Access Compliance Report

Public Rights-of-Way

| Intersection ID: 10207 | Main Street: JOYCE_DR | Cross Street: KILDARE_DR | Location: NE |
| ADA ID: 59C15DD6F2A0 | Ramp Type: BlendTrans2 | Initial Pass/Fail: Fail | Overall Compliance: No |

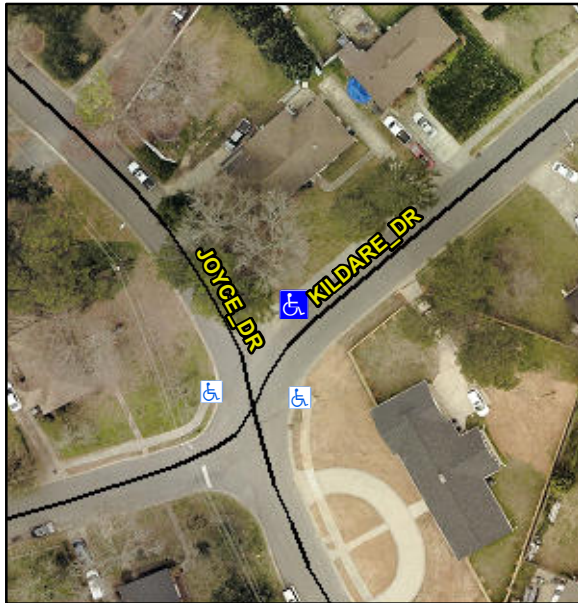
CURB LIP 1.0

Not Found, R304.5.1

Remove & Replace Curb Ramp With Two New Directional Ramps or Equivalent.
